# HARNETT CENTRAL PRESS BOX

HARNETT CENTRAL PRESS BOX  
HARNETT COUNTY SCHOOLS  
2911 HARNETT CENTRAL RD, ANGIER, NC 27501

PROJECT INFORMATION:  
DATE: 1/10/2023  
DRAWN BY: RDH  
CHECKED BY: JEL  
SHEET TITLE  
COVER SHEET  
SHEET NUMBER  
G-001  
PROJECT# 21-11110

SHEET TITLE: **FRAMING PLAN**  
 SHEET NUMBER: **S-102**  
 PROJECT#: 21-1110

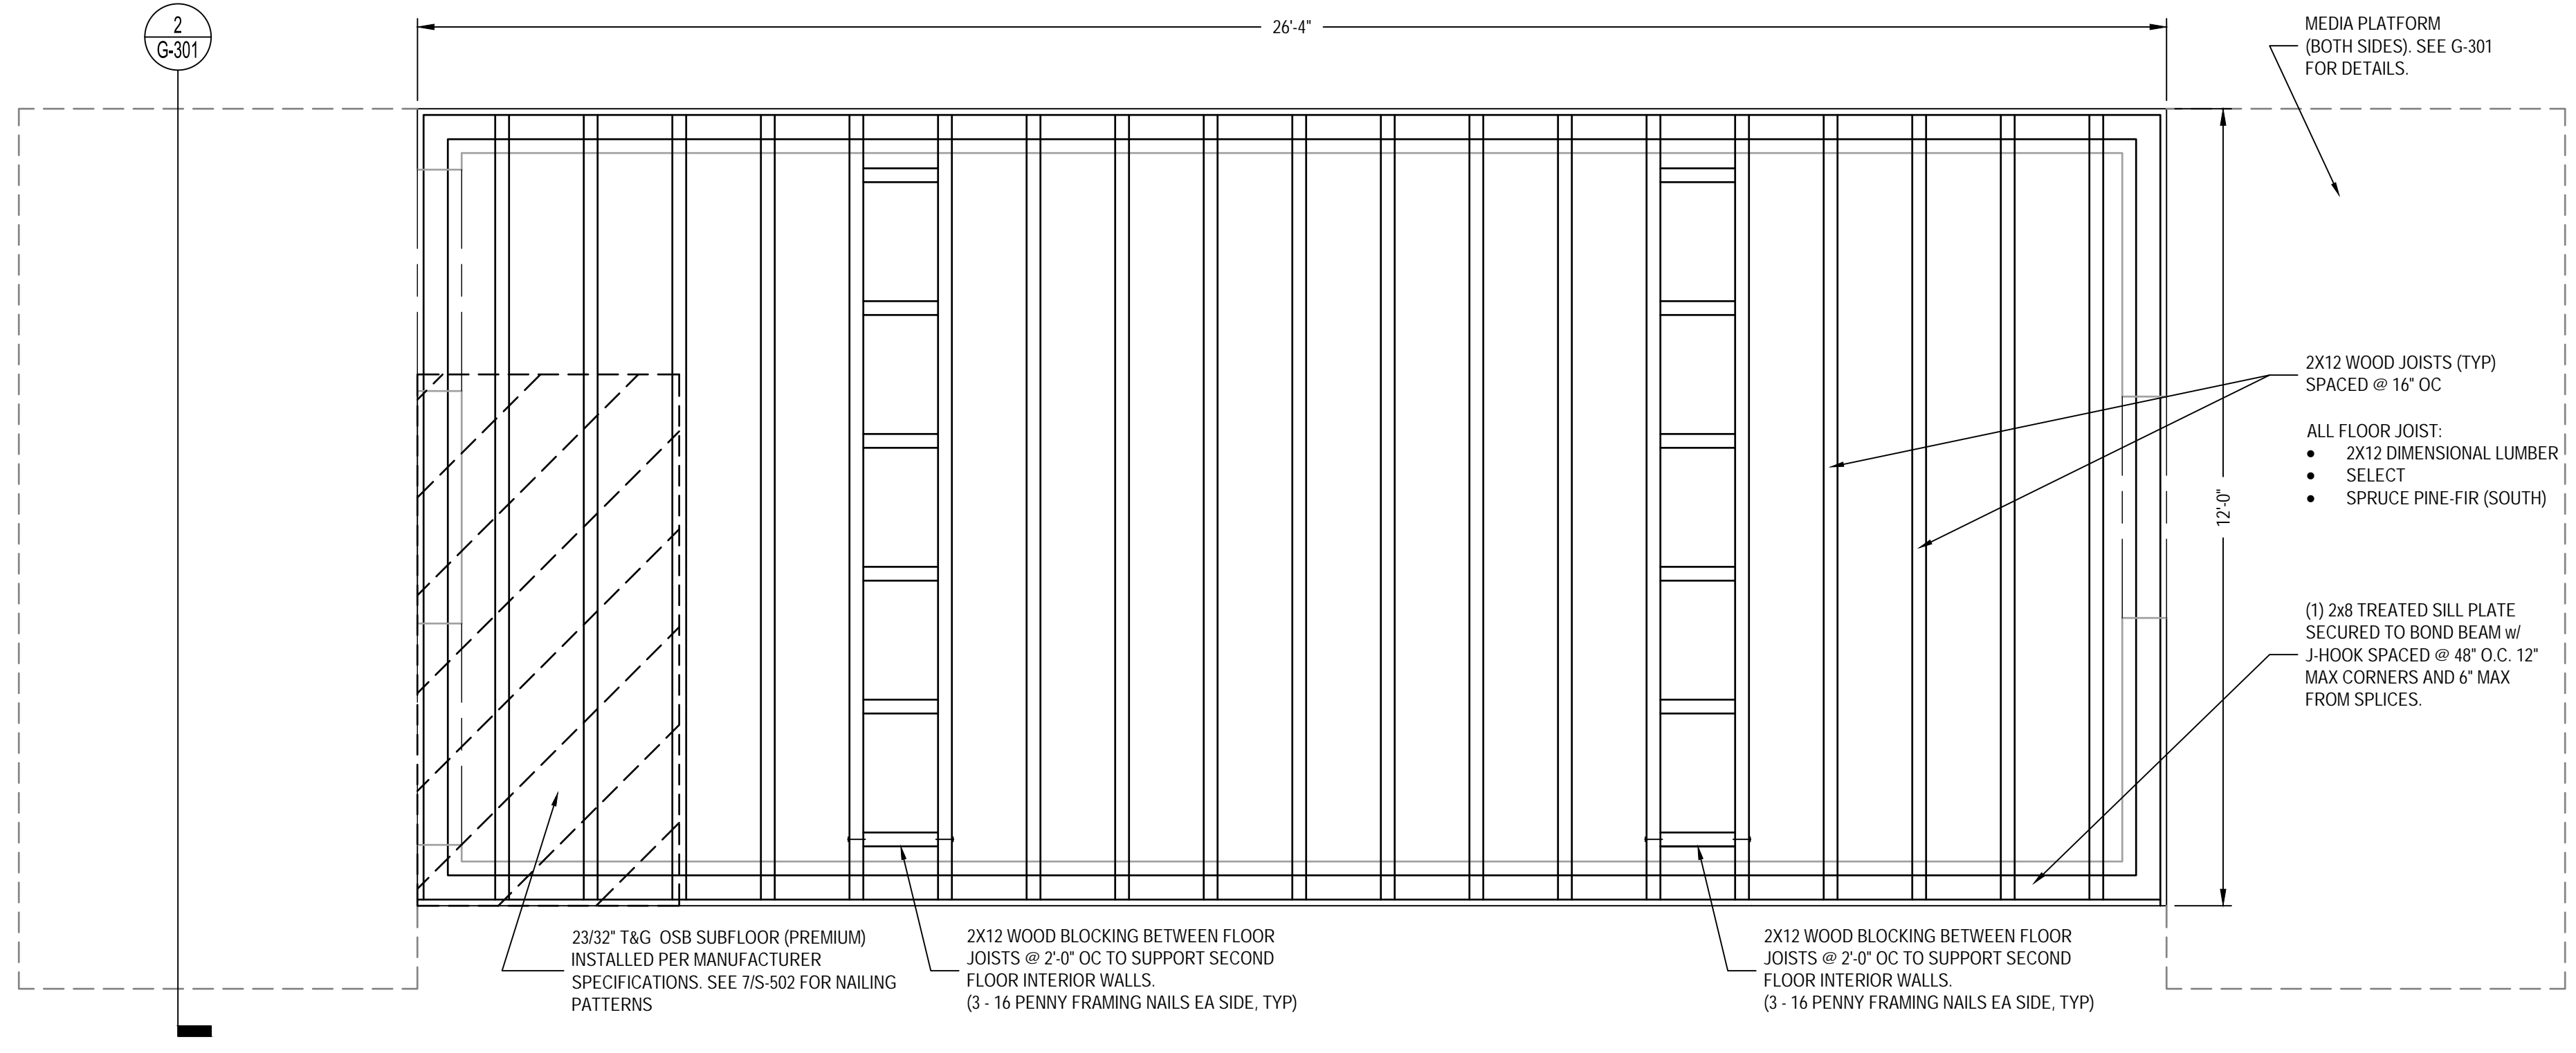
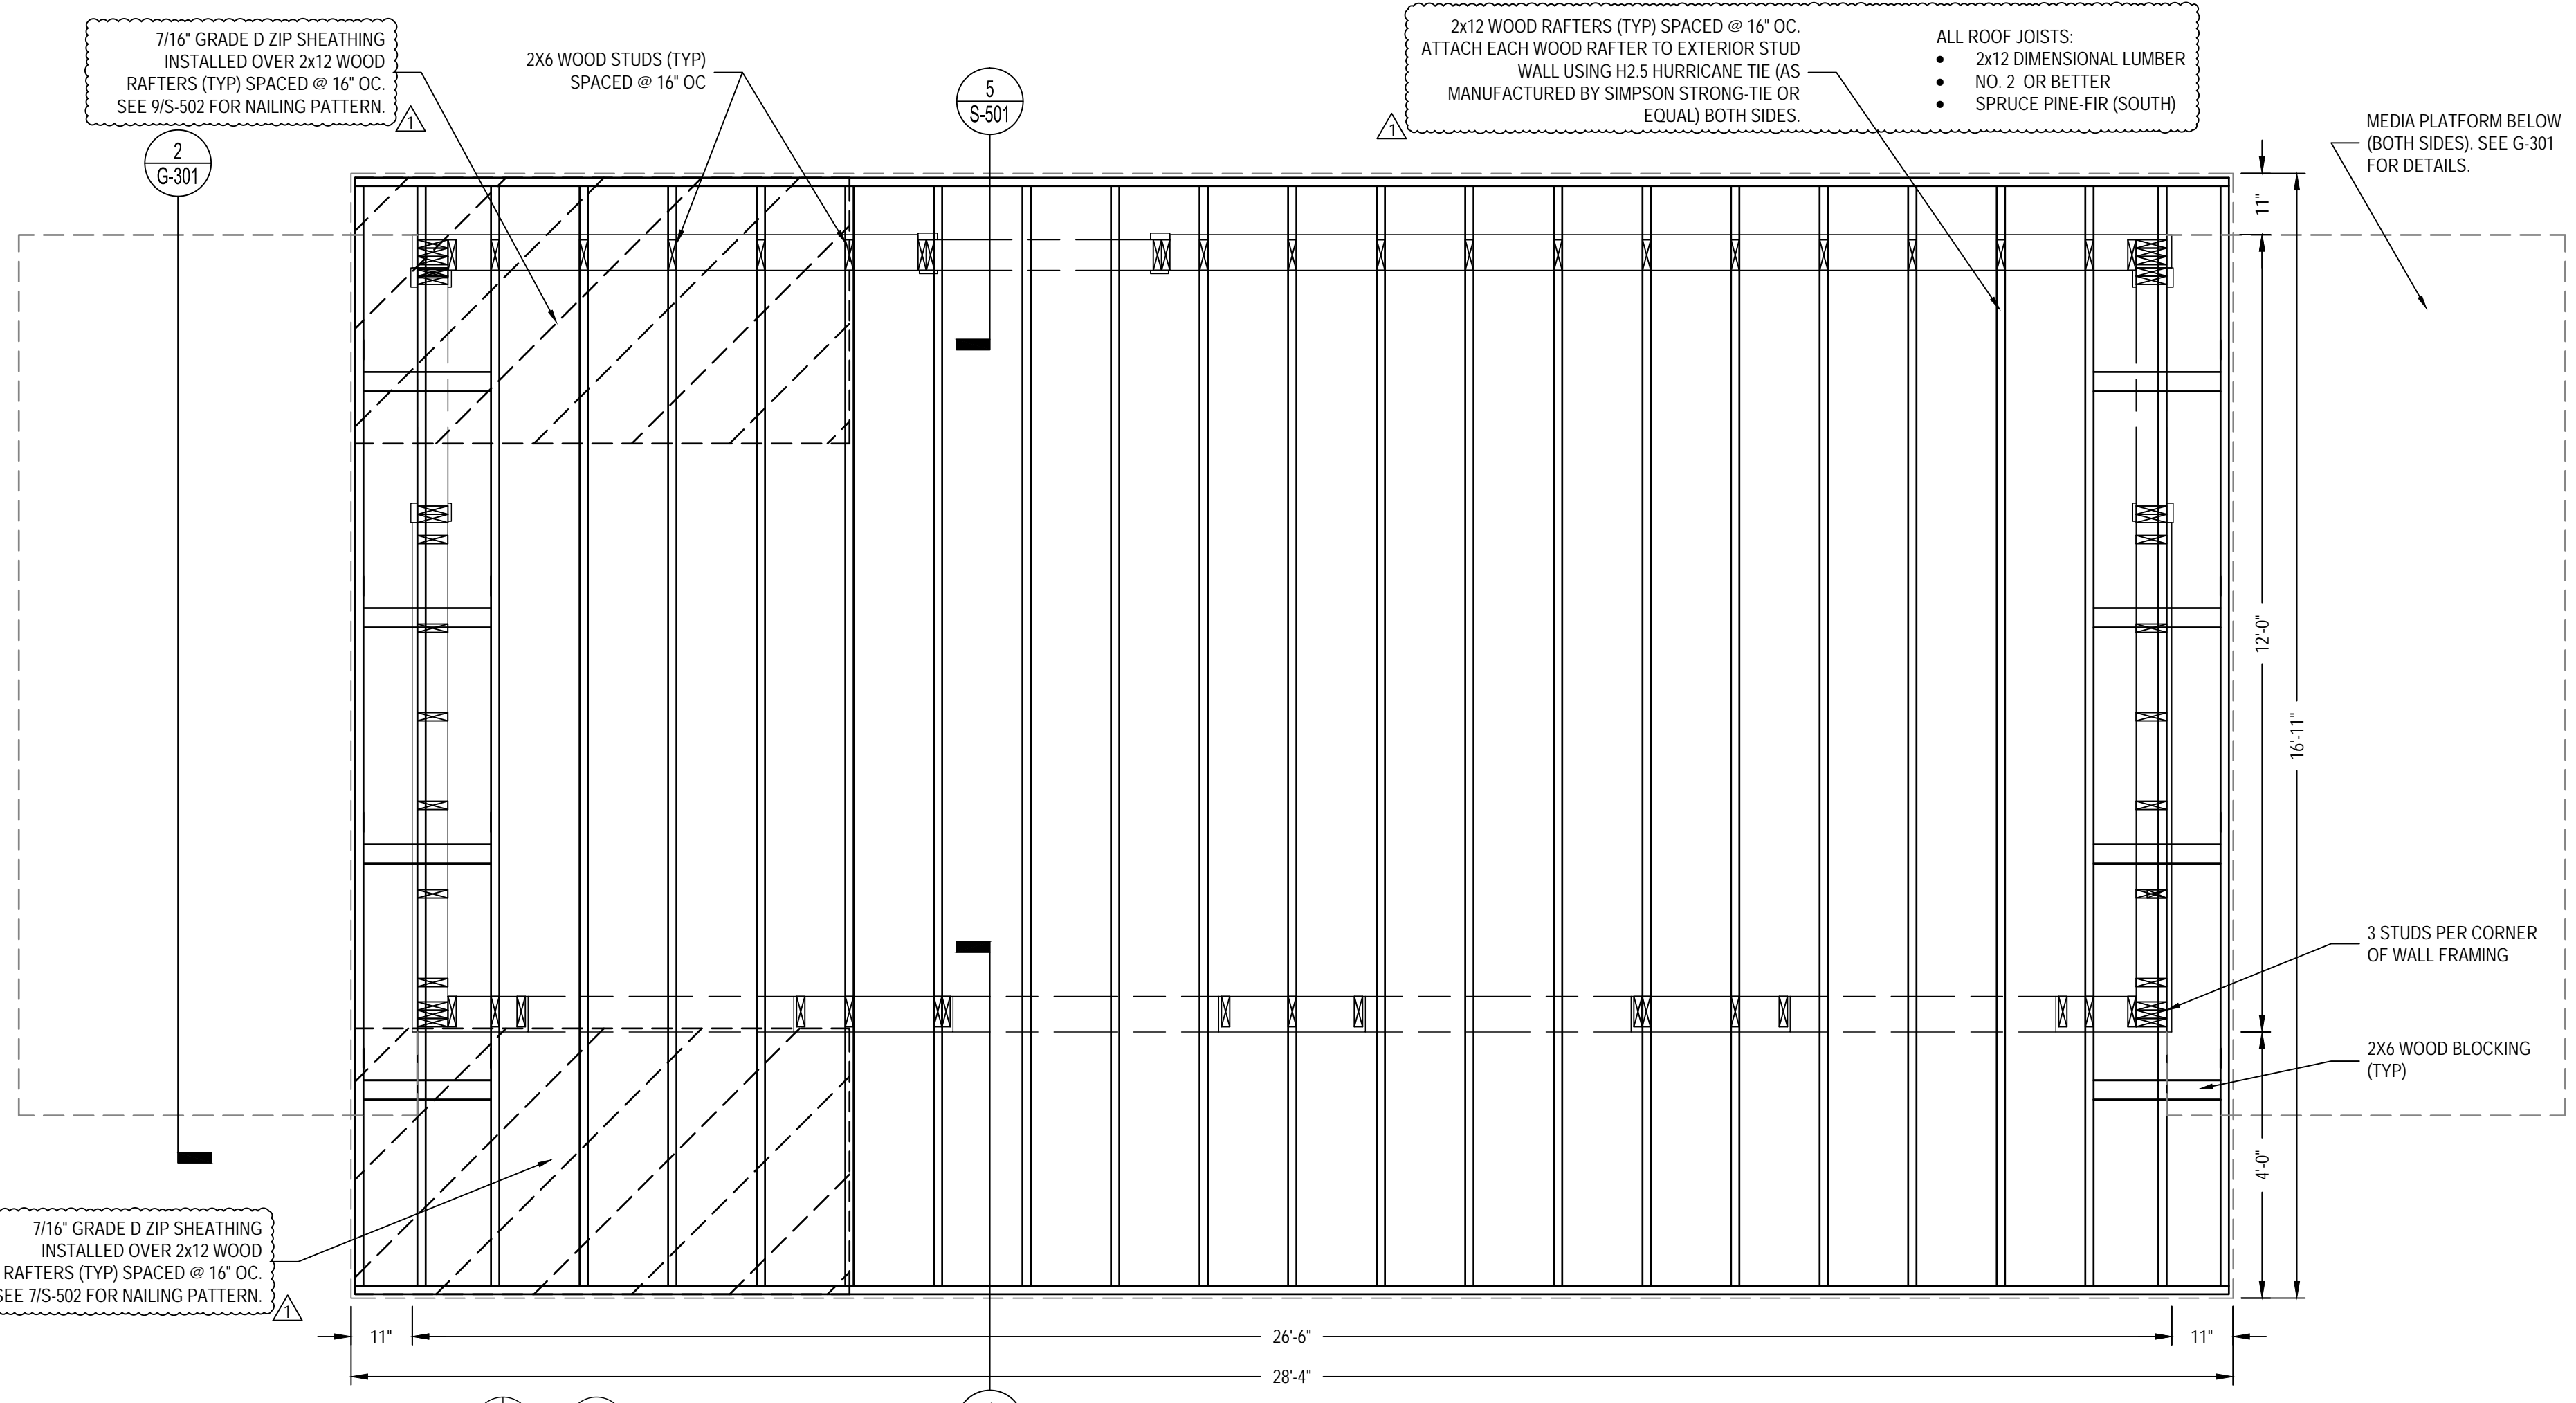
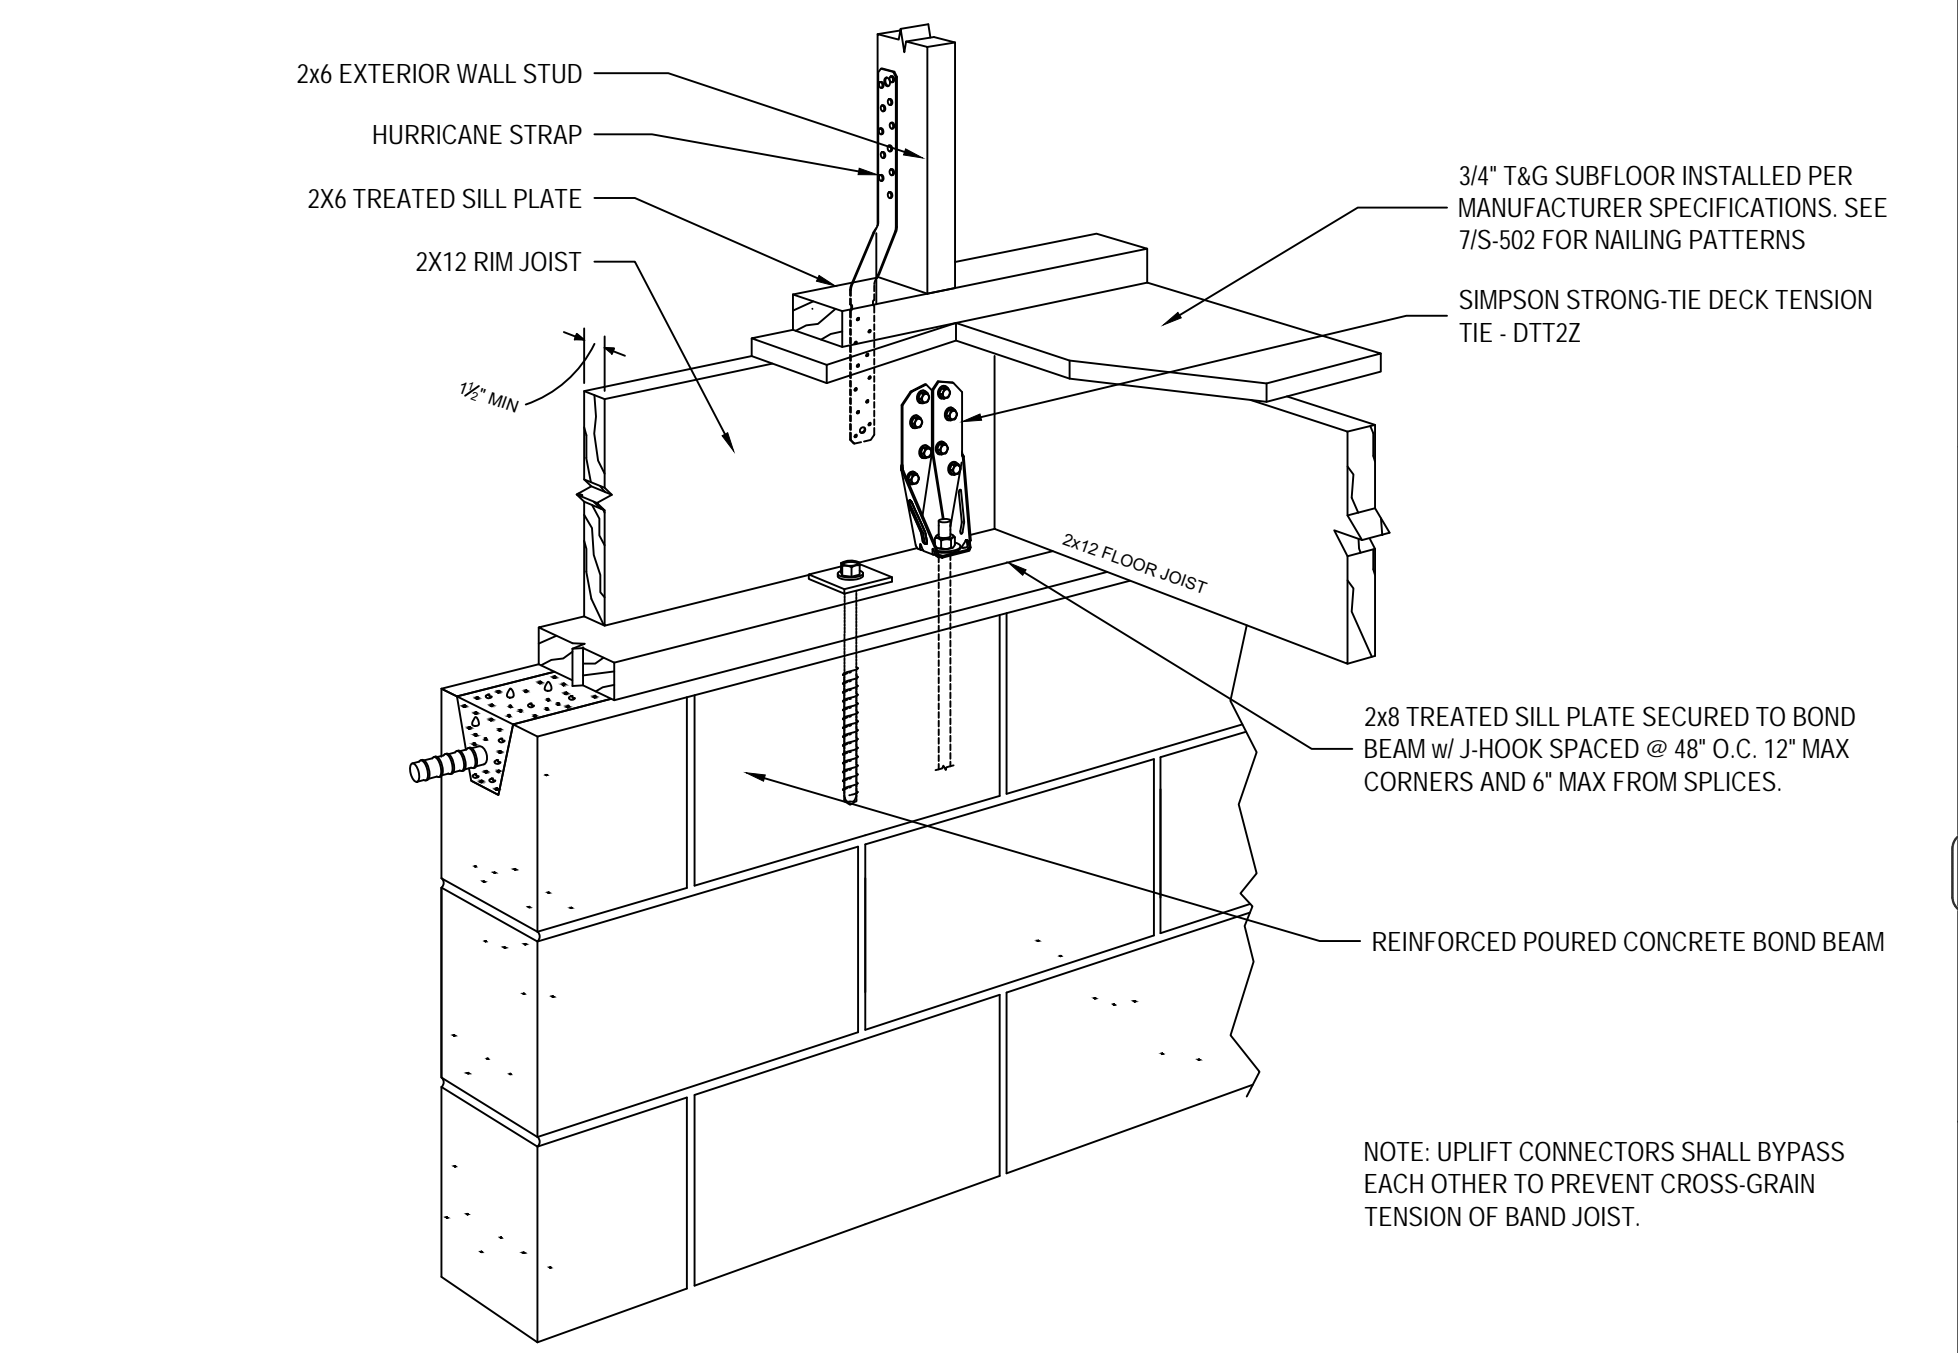
REVISION	DATE	DESCRIPTION
1	4/13/2023	ROOF RAFTERS AND INSULATION CHANGED
2		
3		
4		
5
